N6954A-02

Modification Recommended Service Note

N6954A – Advanced Power System, DC Power Supply, 80V, 12.5A, 1000W

The Problem – Charge Present on the AC terminal when unplugging the unit.

Figure 12

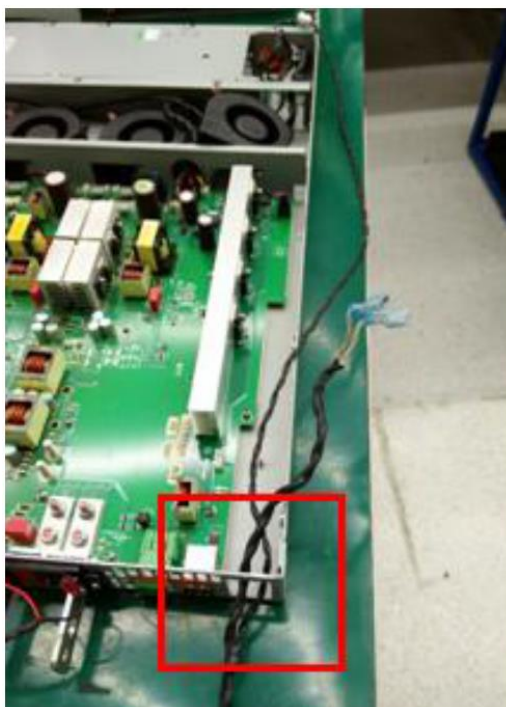
New AC line filter (5190-4495) with 15GENG3E-R is used to replace the existing AC line filter to optimize the discharge time.

12. Insert the AC line cable (5190-4495) into chassis as shown in
13. Figure 12.
